Subject: Submission for DA2020/0302

Attached is a letter and some supporting documents in relation to DA2020/0302, at 41 Upper Clifford Avenue, Fairlight. Can you please add this to the submissions for the DA.

PROJECT DETAILS
DUAL OCCUPANCY WITH BASEMENT CARPARKING
AND SINGLE DWELLING AT
41 UPPER CLIFFORD AVE
FAIRLIGHT NSW 2094

GROUND FLOOR
PLAN

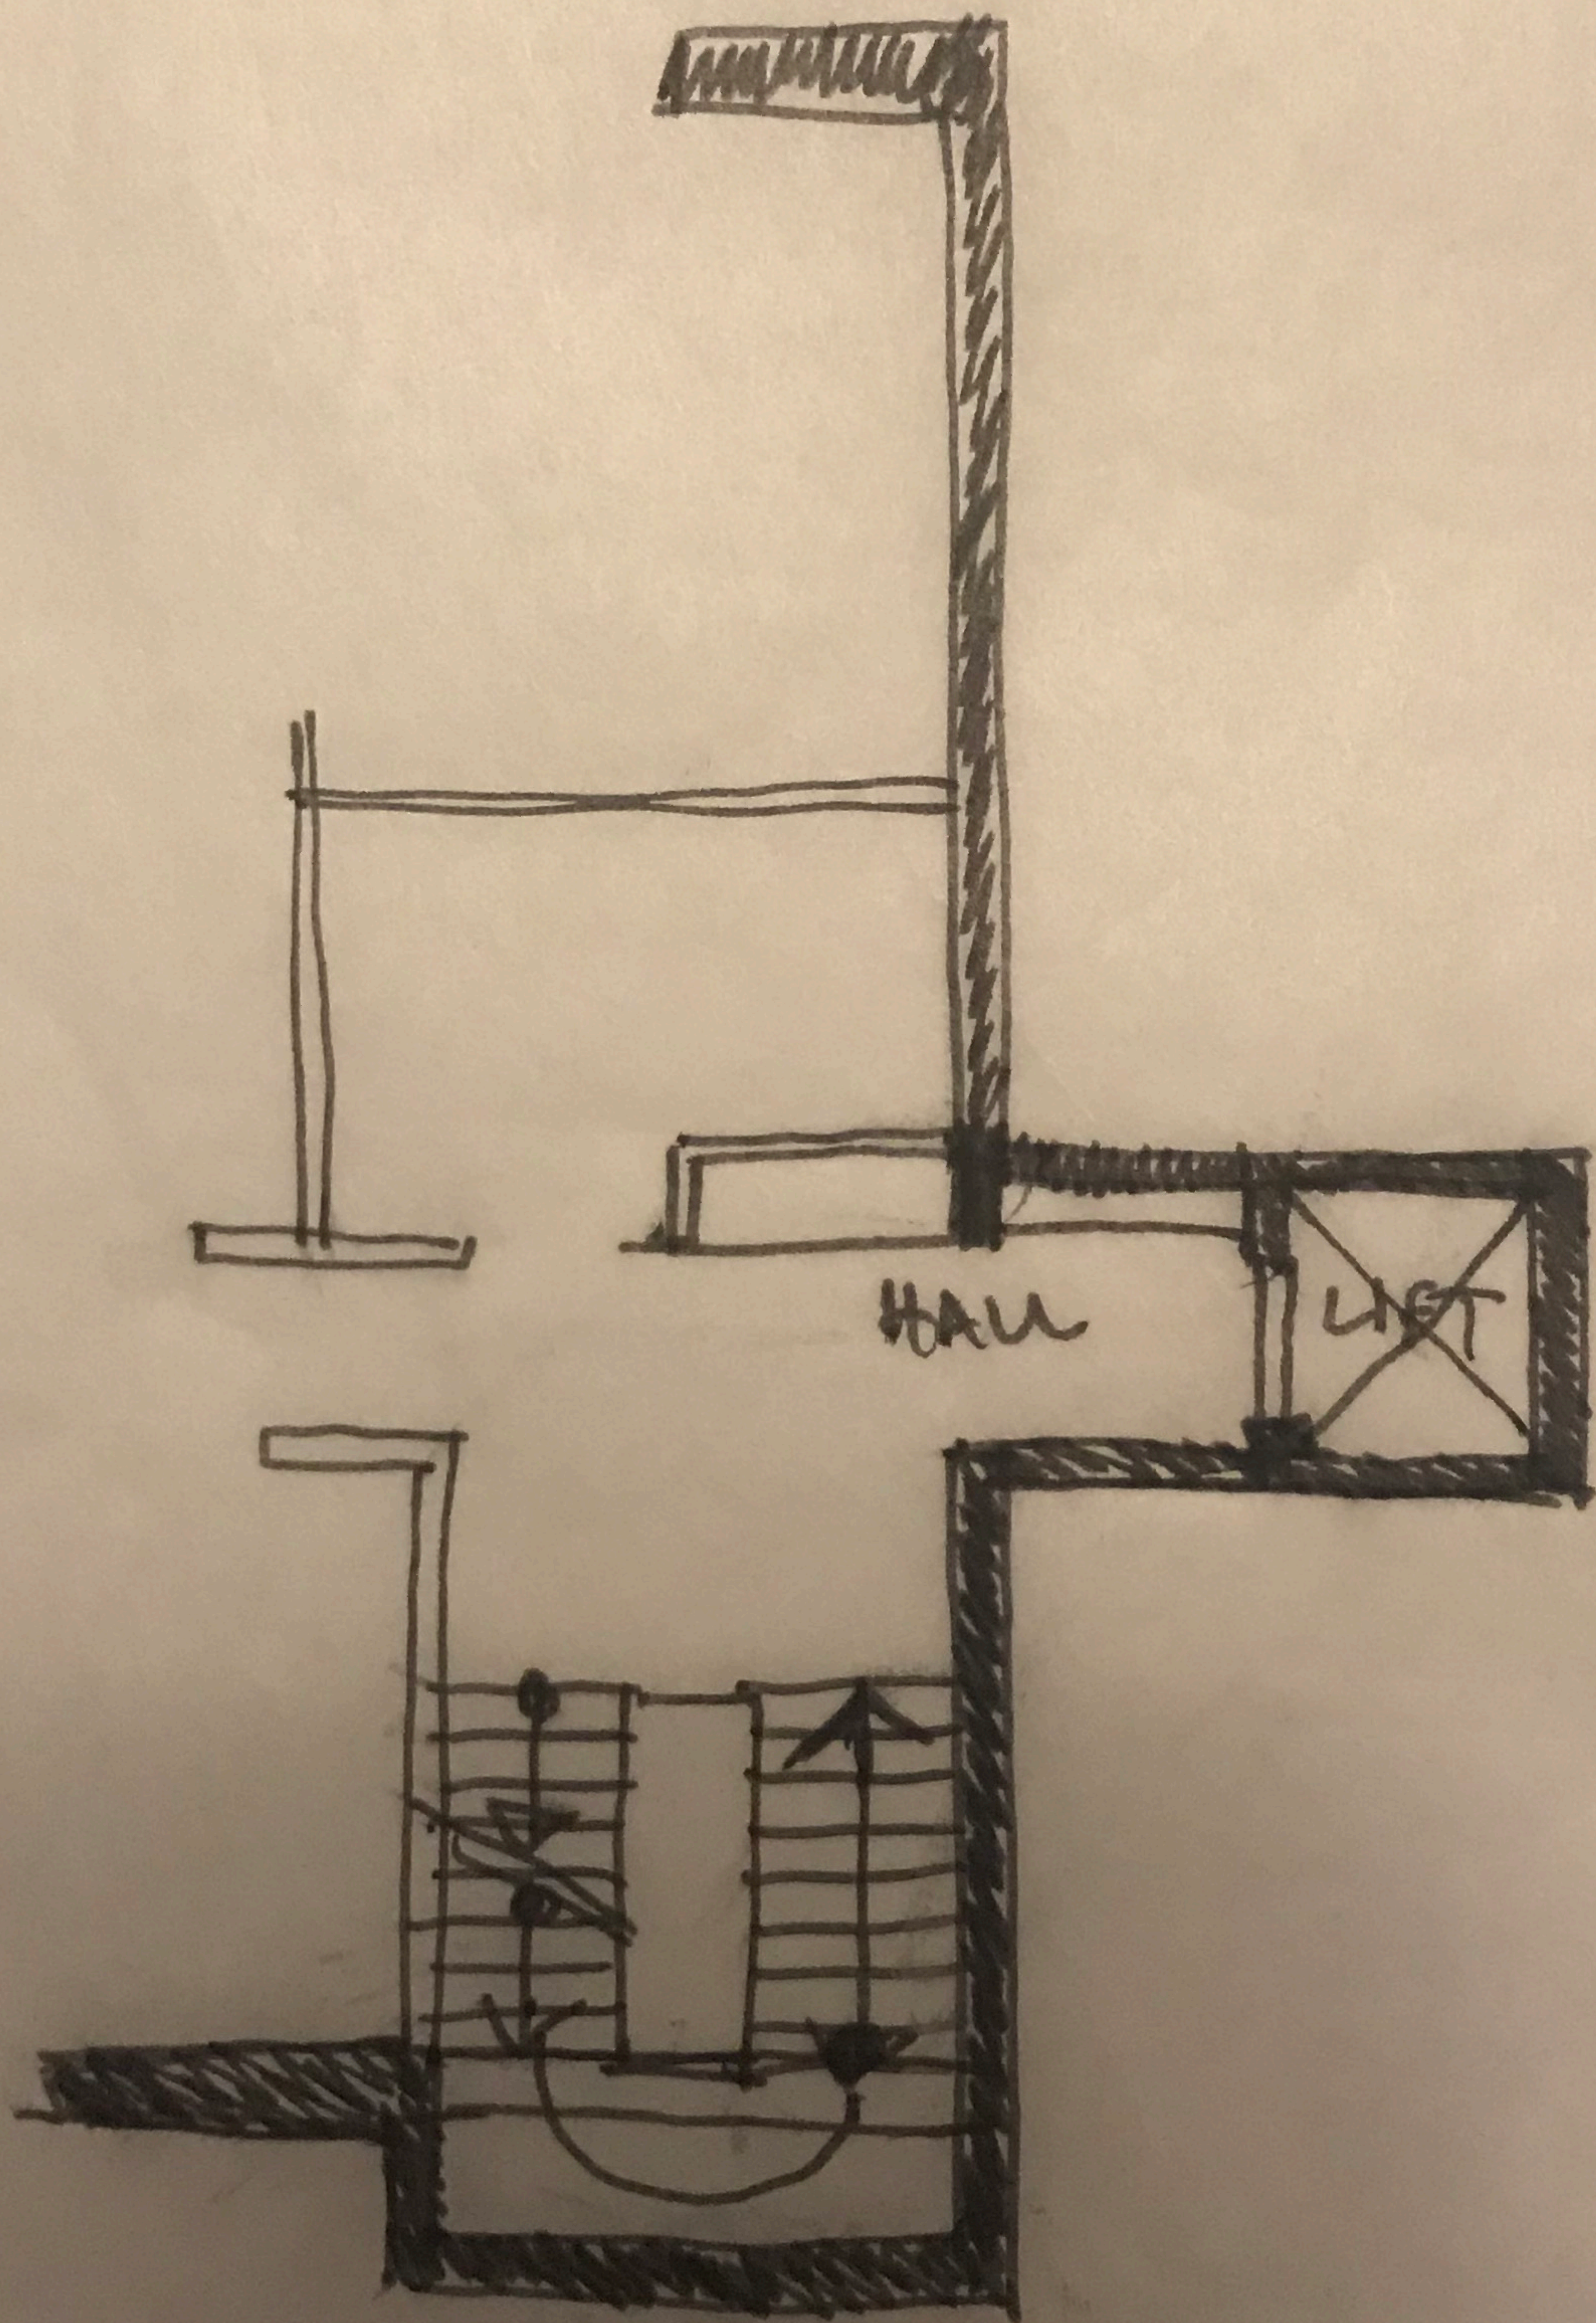
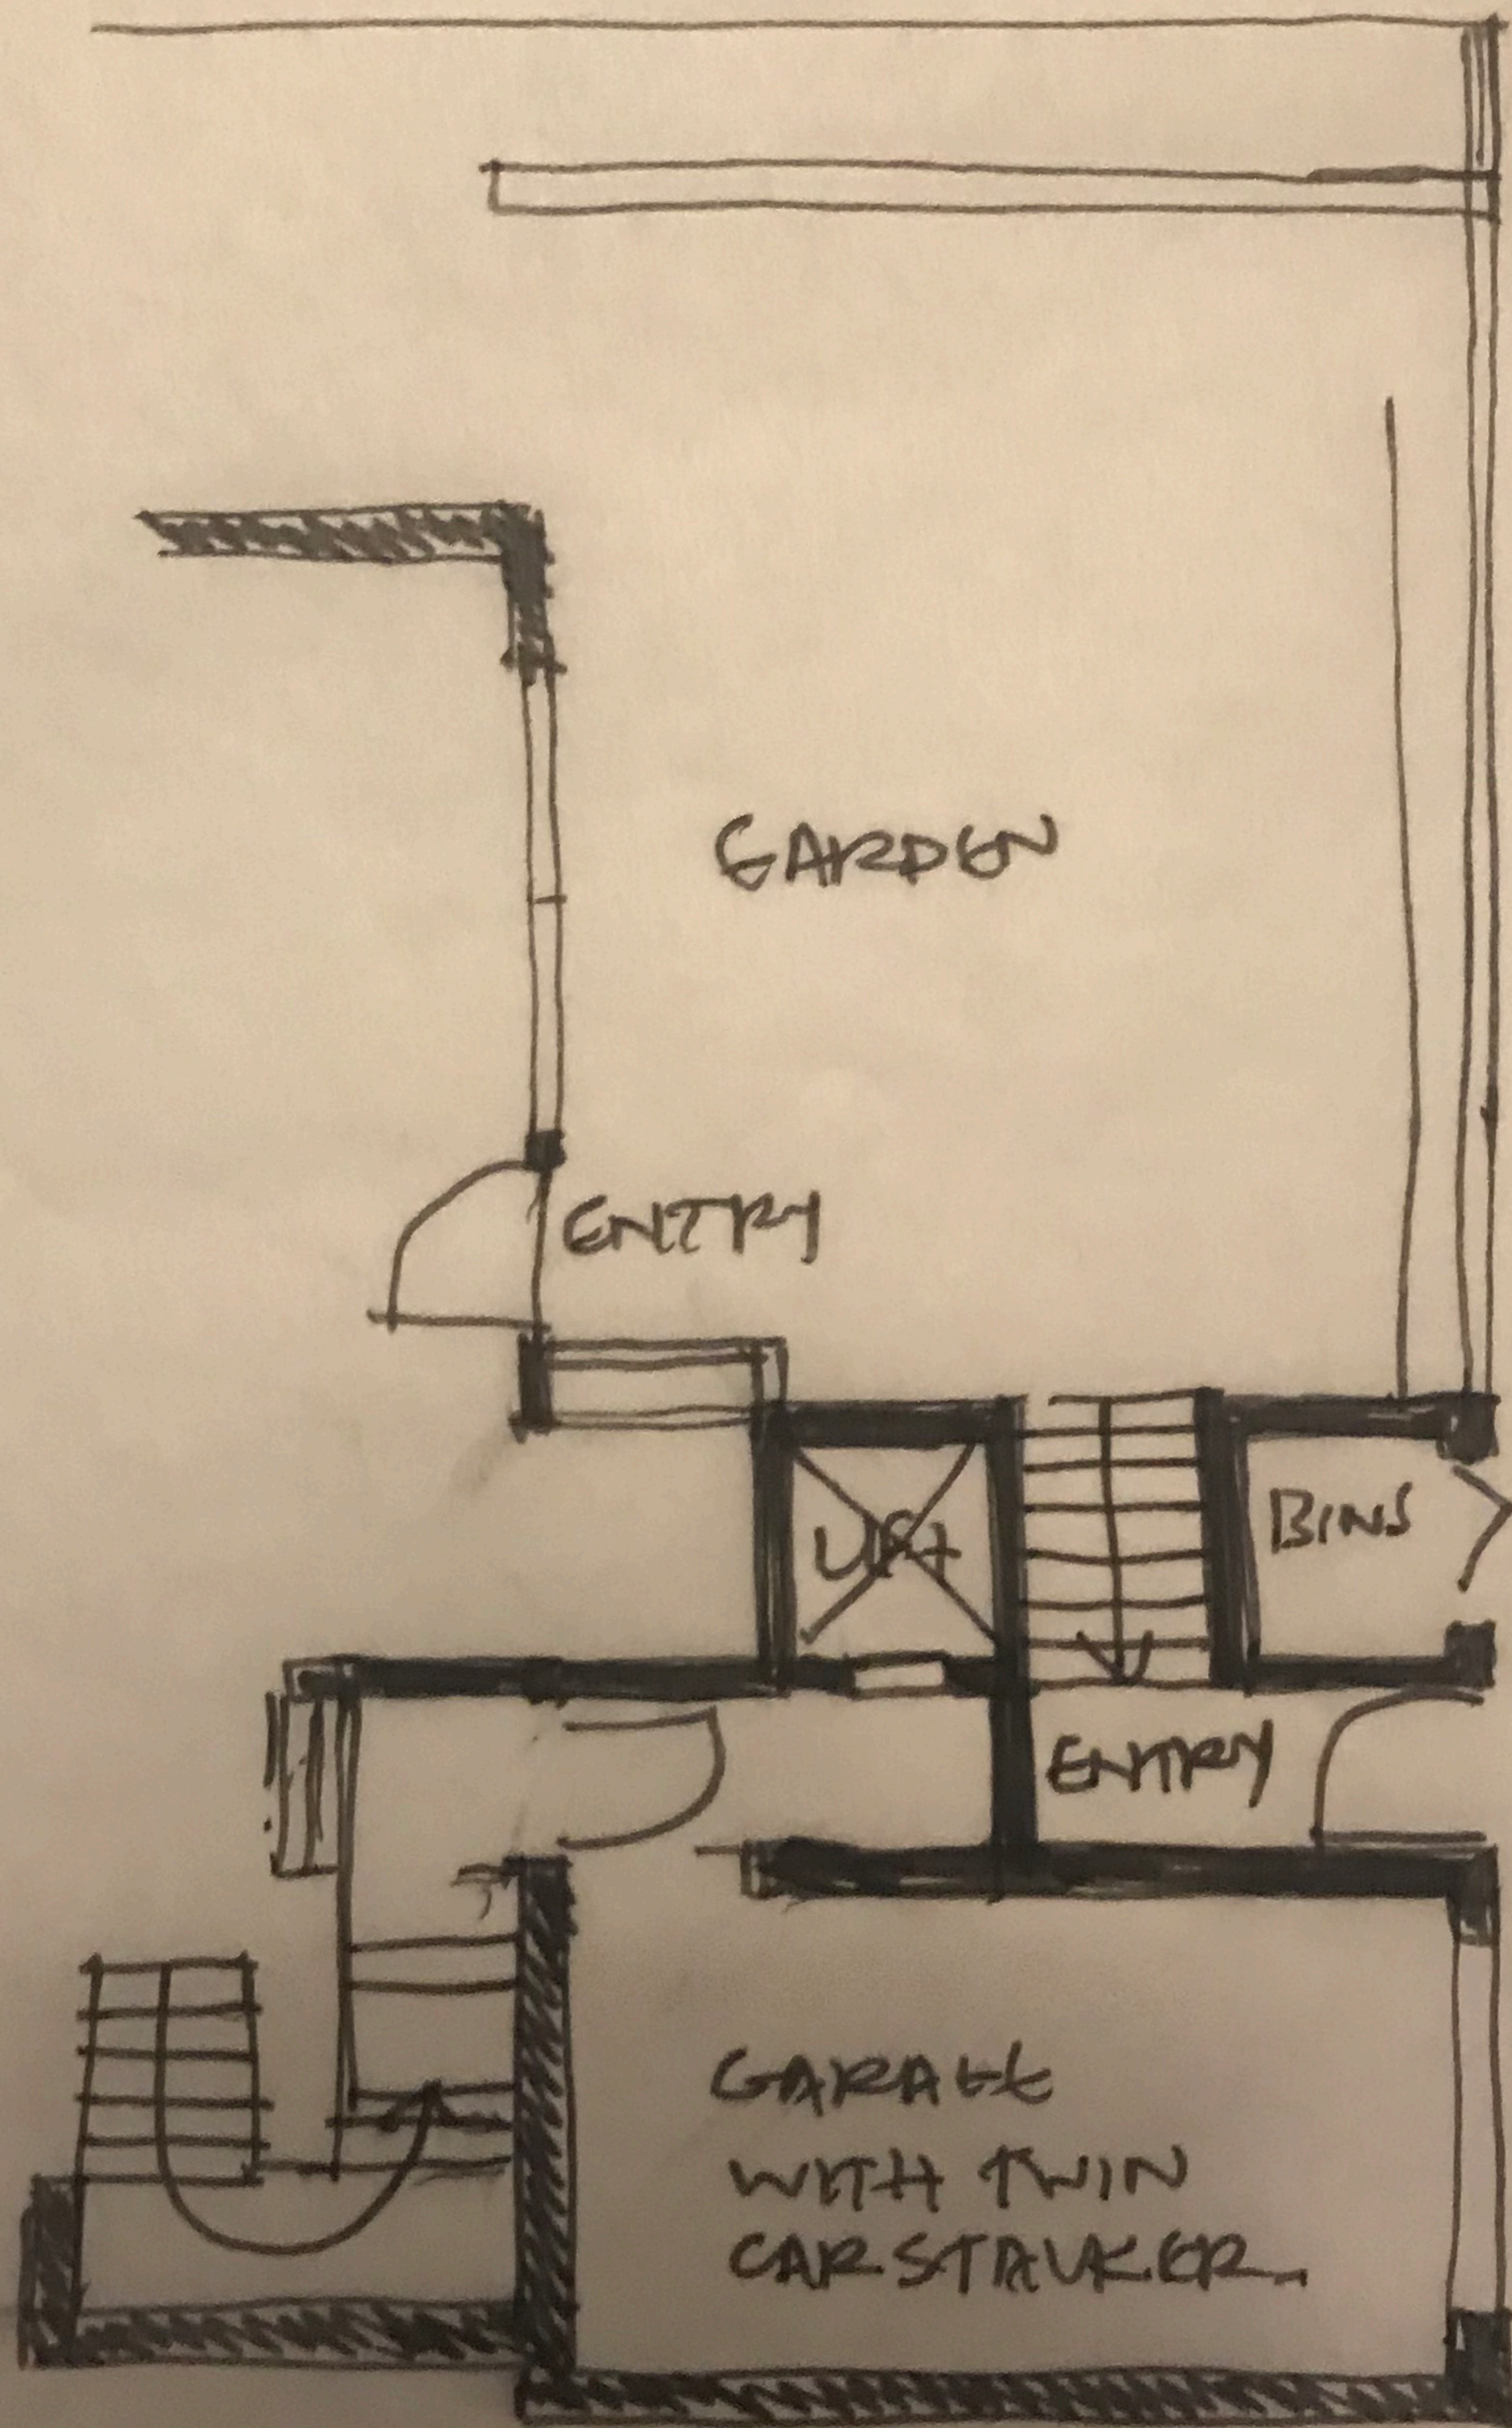
- ii. By retaining a single-width garage in the same place as the existing garage but moving to a car stacker to provide two spots. This would remove the need for a double-width garage which is what causes a large part of the view loss for us. Movement of the position of the lift with the resulting overrun would also assist. Please see attached sketch designs for some potential design modifications to suit and information on a suitable type of car stacker; or
